Reference: NHTSA Identification Number 04V-337

Safety Recall D33 – Valve Cover Studs

2004 (KJ) Jeep® Liberty

Figure 1

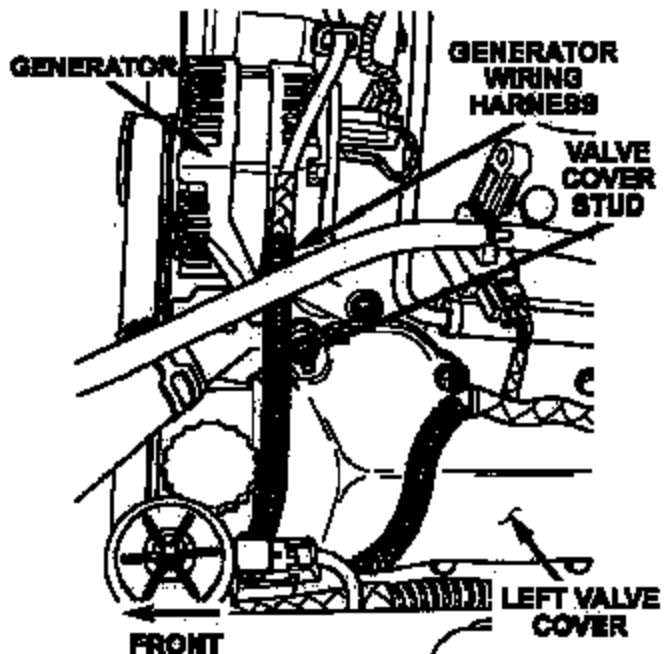
1. Open the hood.
2. Inspect the generator wiring harness where it passes the valve cover stud located on the front left corner of the engine (Figure 1). If the wiring insulation is damaged from contact with the stud, wrap it with high quality electrical tape.
3. Install one of the protective caps over the stud on the left front corner of the valve cover (Figure 1).

Figure 2

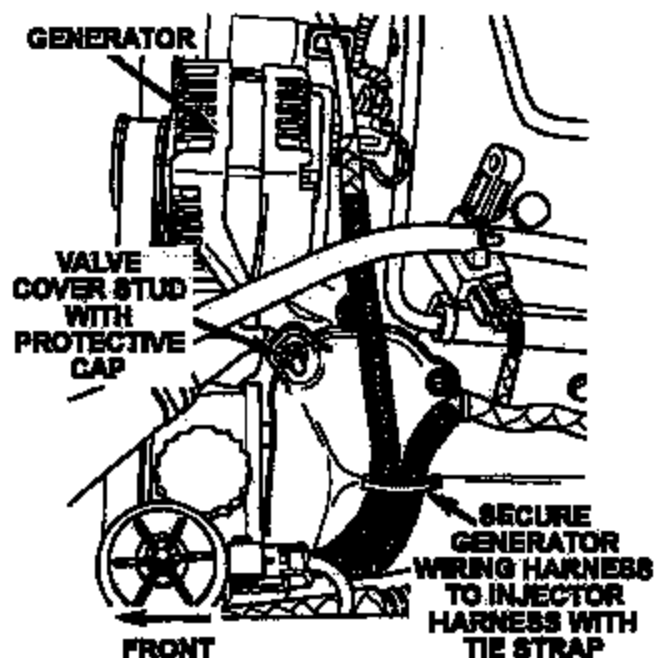
4. Pull the generator wiring harness up and rearward over the valve cover. Secure the generator harness to the injector harness with the provided tie strap (Figure 2).

Figure 3

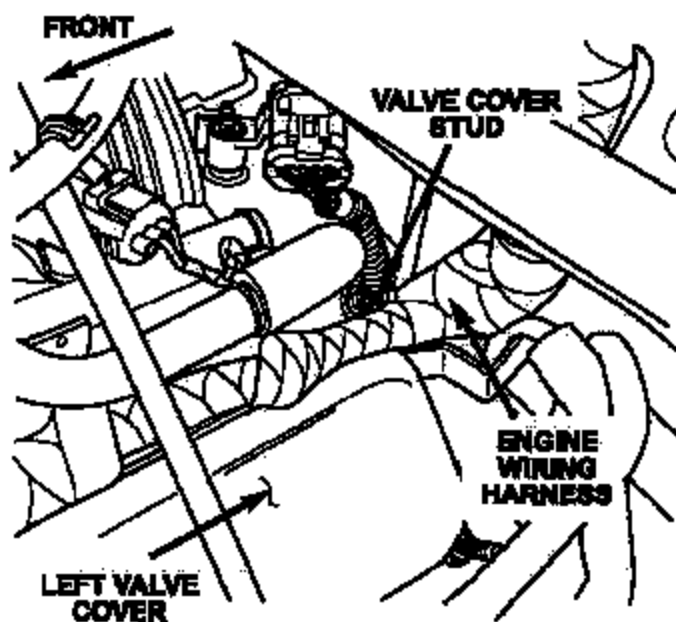
5. Inspect the rear engine wiring harness where it passes the valve cover stud that is located on the rear left corner of the engine (Figure 3). If the wiring insulation is damaged from contact with the stud, wrap it with high quality electrical tape.

Figure 4

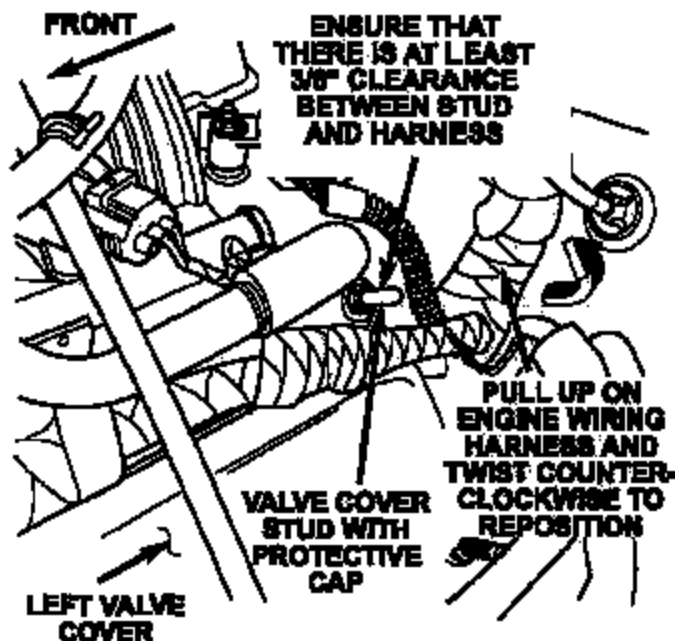
6. Grab the rear engine harness and gently pull it upward while applying a slight counter-clockwise twist to reposition the harness away from the stud (Figure 4). Make sure that there is at least 3/8" (10 mm) clearance between the harness and the stud.
7. Install the other protective cap over the stud on the left rear corner of the valve cover (Figure 4).
